APPLICATION NO.	FILING DATE	FIRST NAMED INVENTOR	ATTORNEY DOCKET NO.	CONFIRMATION NO.
10/617,579	07/11/2003	Daniel P. Turi	6201.001	3667

## Office Action Summary

This is the first Office Action for application number 10/617,579, Detachable Weights for Stabilizing Intravenous Stands, filed on 7/11/03. Claims 1-18 are pending.

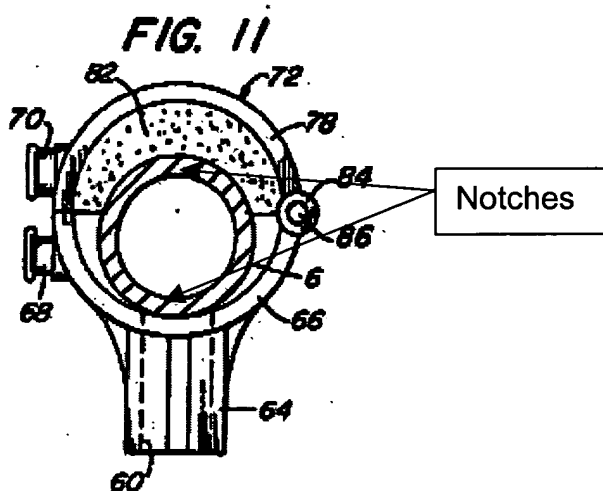
The patent to Schneider discloses a device (72) with a pair of hinged (84, 86) connected planar bodies (66, 78) placed atop a wheeled (8) carriage of an IV stand (4), with a pole (6) extending vertically upwardly from the carriage, the bodies (66, 78) being moveable towards each other into a closed position about the pole and a latch means (68, 70, 74), which is mounted on the bodies to releasably clamp the pair of bodies in a

closed position, the latch means being interconnected by the hinge. Schneider also teaches that the bodies are in contiguous linear engagement with each other, including a semi-circular notches (See The Drawing Below) formed intermediate to each body's opposite ends, making a clamshell structure and being in circumscribing engagement with the pole of the IV stand, while being swung toward each other in a closed position and a swung away from each other to an open position. Schneider also teaches a liner of resiliently deformable material (82, See Col. 5 lines 59-65 for material selection) on the mating and in the notches.
